PLANNING COMMITTEE – 23rd April 2024

Reference Number: 23/00189/FL

Proposal Description: Residential development of former Derbyshire County Council (DCC) Highways storage depot to erect 5 detached two storey dwellings and creation of new access (Amended Plans)

At: Highways Storage Lane, Chesterfield Road, Grassmoor

Figure 4: Indicative site levels

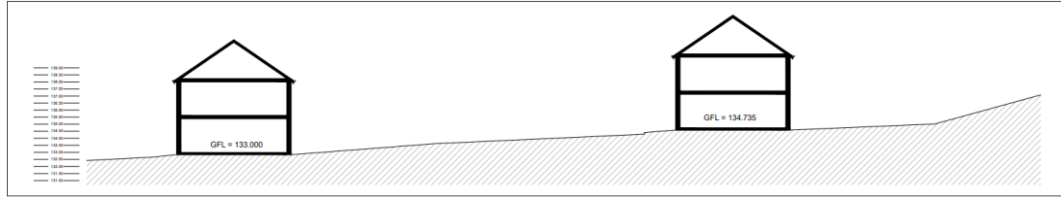
- 7.11 The site slopes from the rear down to Chesterfield Road, with properties on a new development to the north positioned in an elevated position to this site. An indicative levels plan (see Figure 4 below) has been submitted showing the changes in levels across the site. Full levels details will need to be submitted to and approved by the Local Planning Authority, this can be controlled by way of condition.

3) Notwithstanding the submitted details, before development commences, details of the existing ground levels, proposed finished floor levels of the dwellings and the proposed finished ground levels of the site shall be submitted to and approved in writing by the Local Planning Authority. The development shall then be carried out in accordance with the approved details.
